Kit No. 23-9020-1 S

- SUBJECT:** FUEL - REPLACEMENT OF THE FUEL BOOST PUMP
- SYNOPSIS OF CHANGE:** Revised the accomplishment instructions to reflect a new fuel boost pump part number.

Issued: February, 1991

Revised: August, 1995

**Fuel Boost Pump Installation
Figure 1**

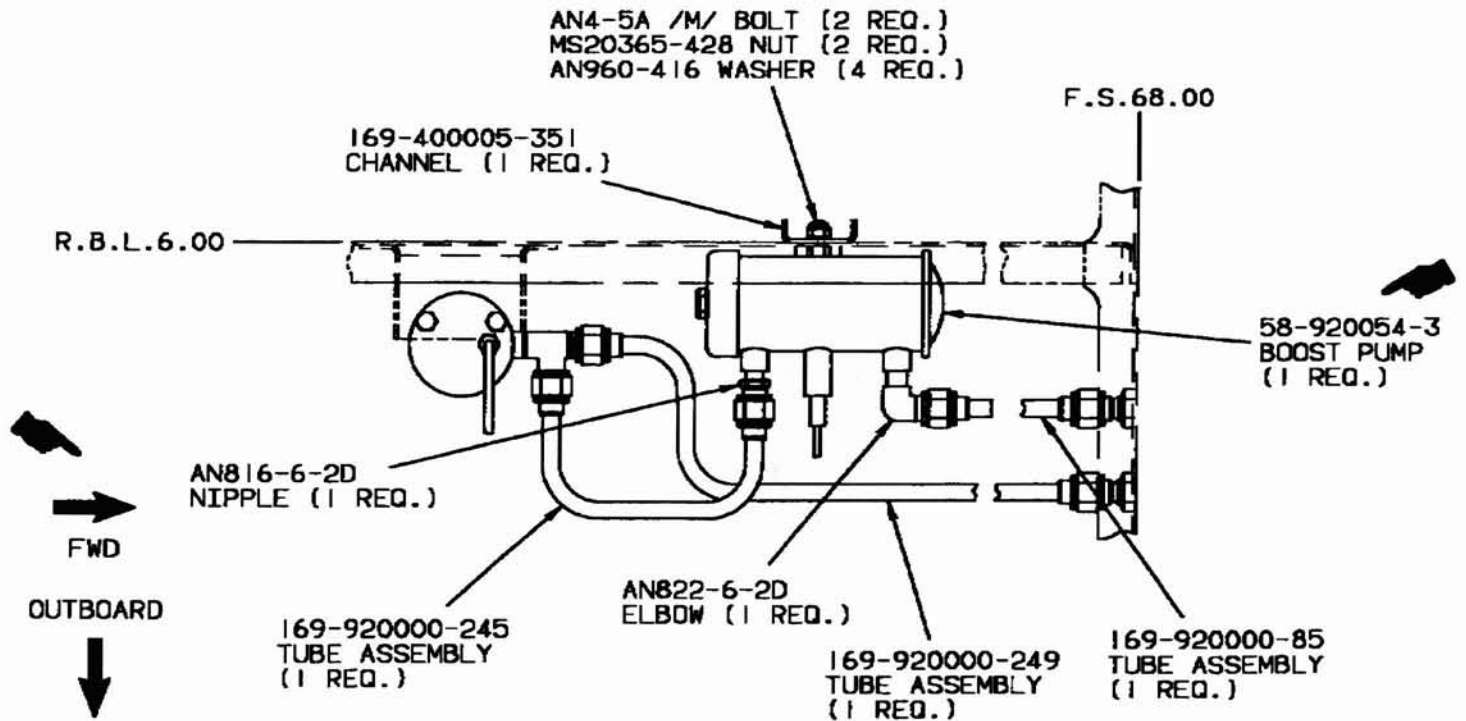
1. Disconnect all electrical power to the airplane.
2. Turn the fuel selector valve to the OFF position.
3. Remove the co-pilot's seat.
4. Remove the co-pilot's rudder pedal cover assembly.
5. Remove the boost pump access plate.
6. Remove the fuel boost pump.
7. Remove the tube assembly from the boost pump to the firewall.
8. Remove the tube assembly from the firewall to the strainer tee.
9. Remove the tube assembly from the strainer tee to the boost pump.
10. Install an AN816-6-2D nipple in the "In" port of the new boost pump.
11. Install an AN822-6-2D elbow in the "Out" port of the new boost pump.
12. Install the P/N 58-920054-3 boost pump and P/N 169-400005-351 channel with a P/N AN4-5A/M/ bolt, P/N AN960-416 washer and MS20365-428 nut through the existing holes in the keel at F.S. 78.40, located 10.4 inches aft of the firewall.

Trim the diagonal channel between the inboard and outboard keel as necessary to provide clearance between the channel and the new boost pump.

13. Referring to Figure 1, complete the installation of the fuel line tube assemblies.

It may be necessary to make minor adjustments to the tube assemblies and/or shim the firewall fittings in order to ensure proper alignment of the installation. Use care when hand-bending the tube assemblies to prevent crimping or damaging them.
